HISTORIC AND DESIGN REVIEW COMMISSION

HDRC CASE NO: 2023-351
ADDRESS: 3853 N ST MARYS ST
LEGAL DESCRIPTION: NCB A49 PART OF A-2, A-4, A-52 (208 AC)
ZONING: R-5, HL
CITY COUNCIL DIST.: 2
APPLICANT: James Torres/Don B. McDonald Architects
OWNER: CITY OF SAN ANTONIO
TYPE OF WORK: New construction of a 2-story restroom structure
APPLICATION RECEIVED: August 18, 2023
60-DAY REVIEW: October 17, 2023
CASE MANAGER: Rachel Rettaliata

The applicant is requesting a Certificate of Appropriateness for approval to construct a 738-square-foot, 2-story restroom structure.

Scale: 1/4"=1'-0"

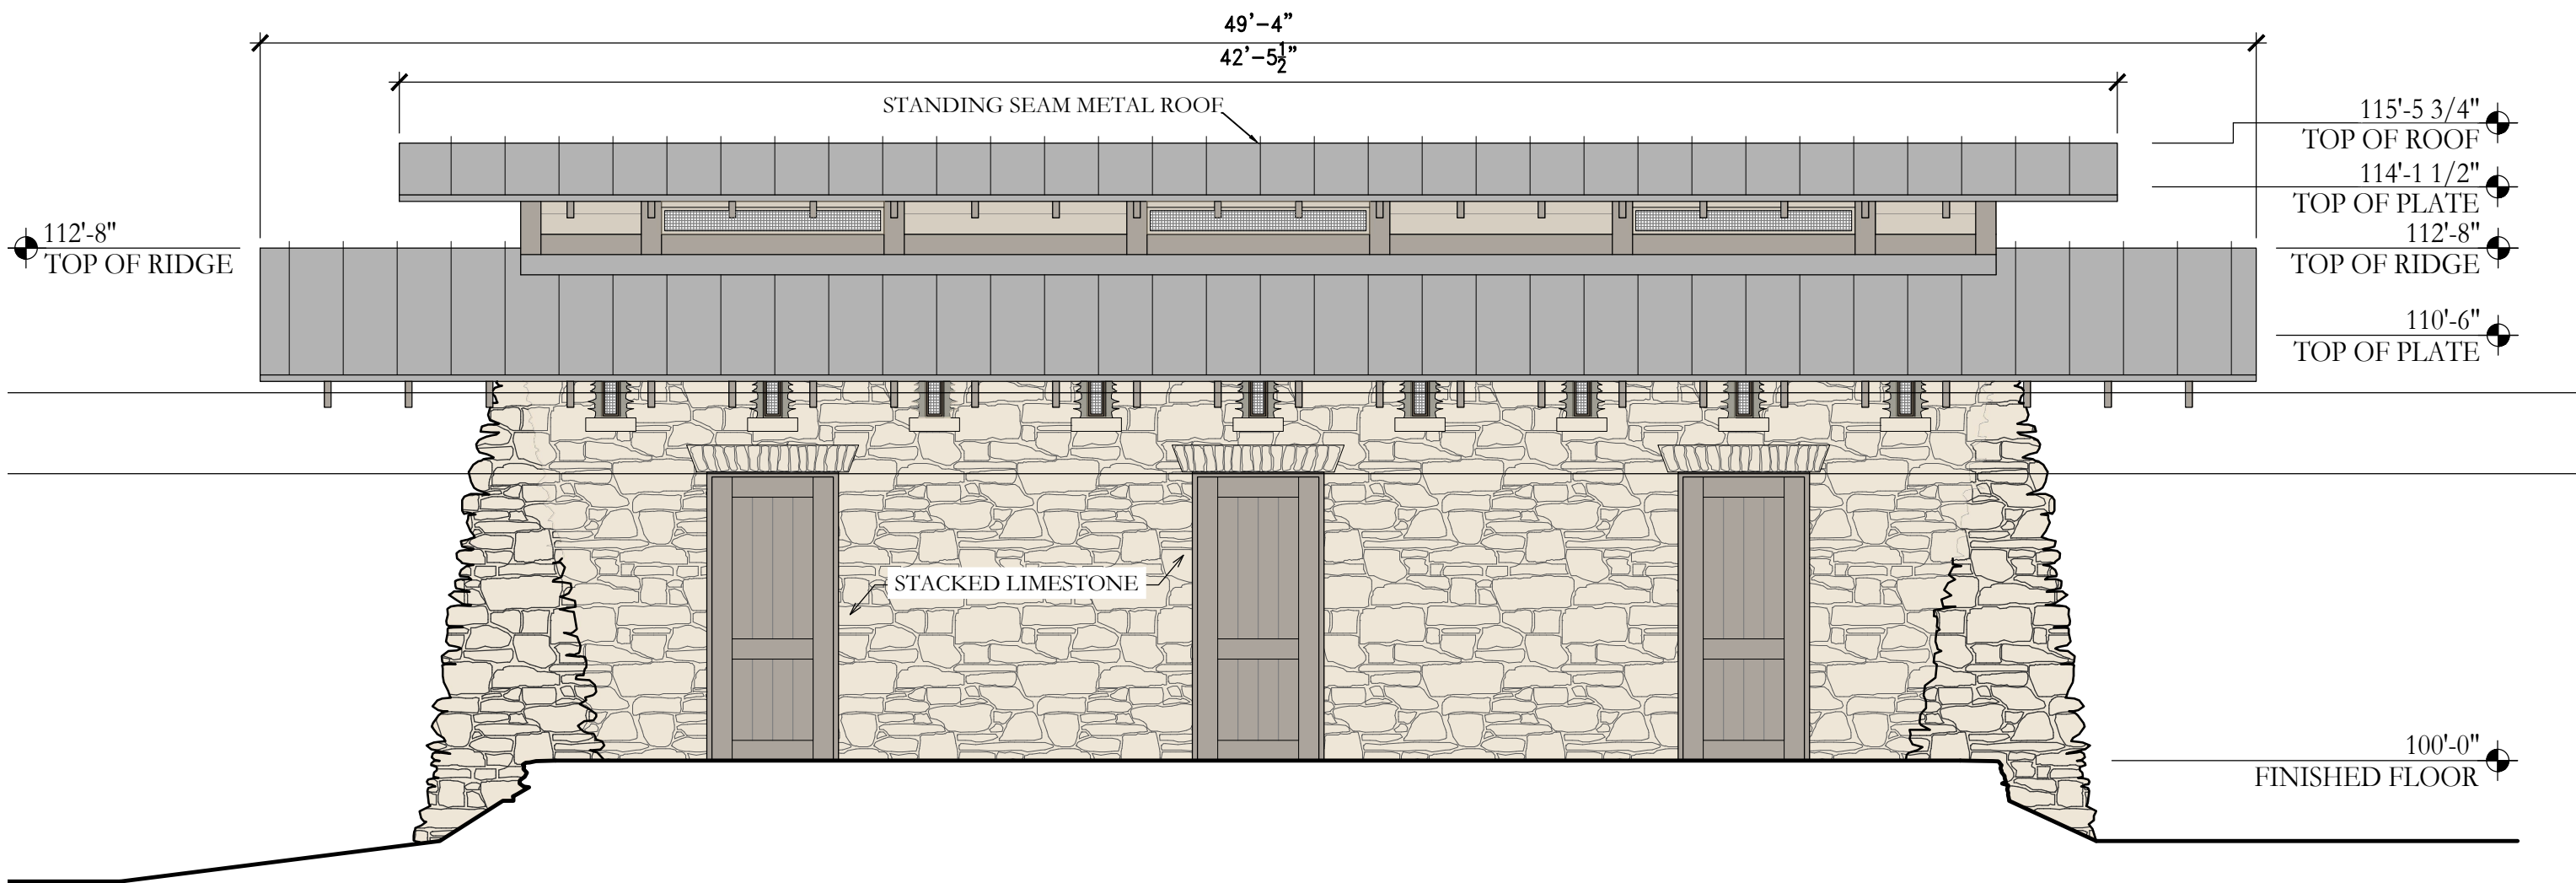
- d. ROOF FORM – The applicant has proposed to install a side gable standing seam metal roof with a row of clerestory windows and a secondary side gable standing seam metal roof. Guideline 2.B.i for New Construction states that new construction should incorporate roof forms—pitch, overhangs, and orientation—that are consistent with those predominantly found in the area. Additionally, Guideline 3.A.iv for New Construction states that new metal roofs should be constructed in a similar fashion as historic metal roofs. Staff finds the proposal consistent with the Guidelines.

- g. MATERIALS: FAÇADE – The applicant has proposed to construct the restroom facility using stacked limestone cladding to match the existing masonry typology at the Sunken Garden. The facility will additionally feature wood rafters, wood beams, and a mahogany drip edge. Guideline 3.A.i for New Construction stipulates that new construction should use materials that match in type, color, and texture traditionally found in the district and materials should not be so dissimilar as to distract from the historic interpretation of the district. For example, corrugated metal siding would not be appropriate for a new structure in a district comprised of homes with wood siding. Staff finds that proposal appropriate.

- i. That the applicant installs a standing seam metal roof featuring panels that are 18 to 21 inches wide, seams that are 1 to 2 inches high, a crimped ridge seam, and a standard galvalume finish. Panels should be smooth without striation or corrugation. Ridges are to feature a double-munch or crimped ridge configuration; no vented ridge caps or end caps are allowed. An inspection must be scheduled with OHP staff prior to the start of work to verify that the roofing material matches the approved specifications.
